IN THE DRAWINGS

REMARKS

Applicants thank the Examiner for the Examiner's timely and thorough search of the art and Office Action. Applicants, by this Amendment, have amended the Claims to overcome all deficiencies noted in the Examiner's Office Action. No new matter has been entered by this Amendment. After entry of this Amendment, Claims 1 – 19 remain pending in the Application.

Fig. 5

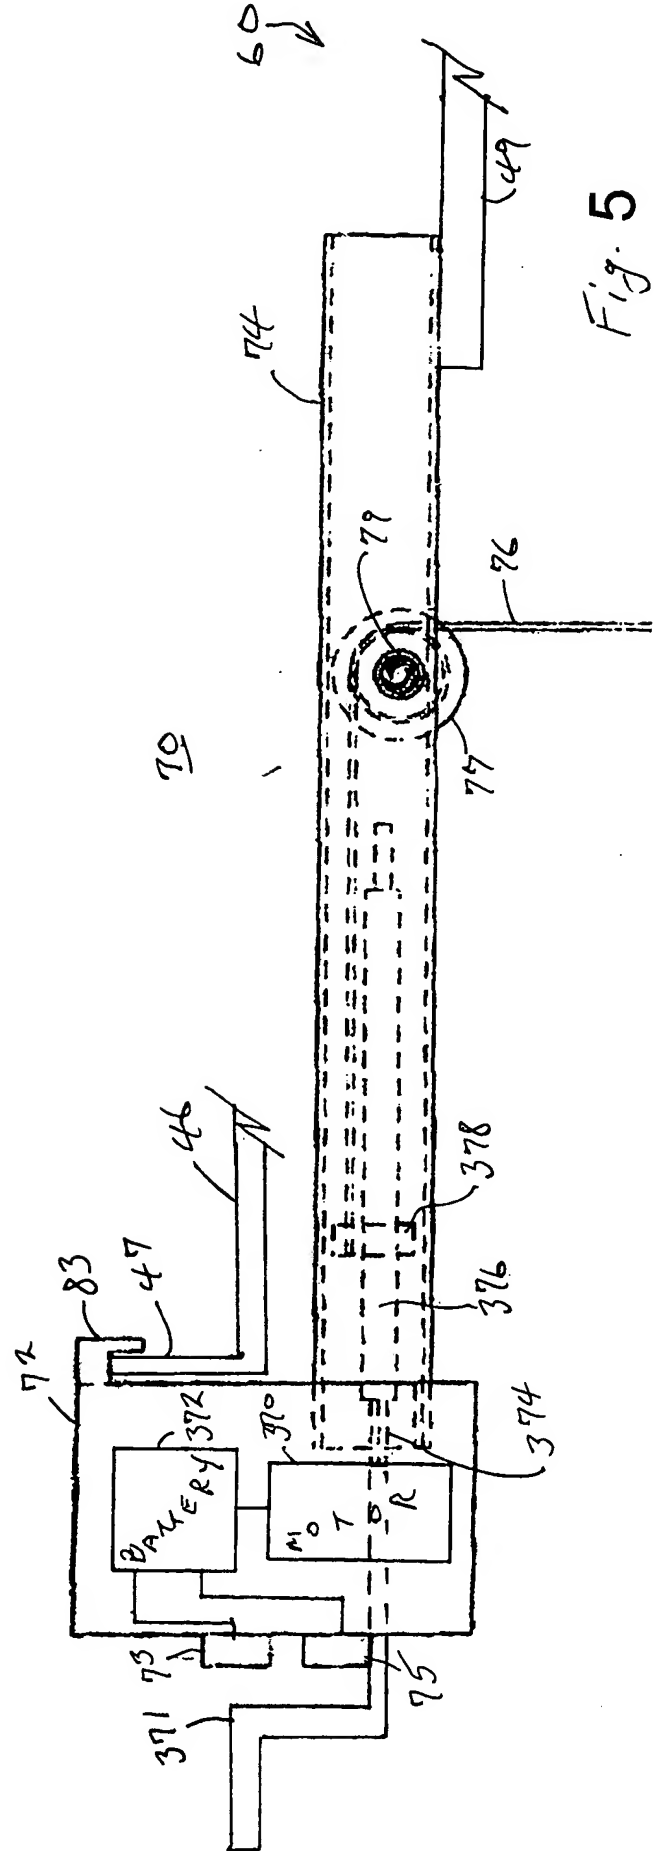
Continuing in the Office Action, the Examiner required formal drawings as a part of the response to the Office Action.

Formal drawings are included with this response. As suggested by the Examiner in the Office Action, a manually operated force generating unit and a hydraulic ram device have been included in the drawings (FIGs. 5 and 7). Annotated marked-up drawings are included herewith to specifically identify in red the changes made in FIGs. 5 and 7. The specification has been amended at pages 5 and 7 to provide antecedent basis for the elements newly included in FIGs. 5 & 7. No new matter has been added by these amendments to FIGs. 5 & 7 or to the Specification. Matter involved in the amendments to FIGs. 5 & 7 and to the Specification is merely a recitation of exemplary structure for implementing elements contained in the original disclosure in the Claims.
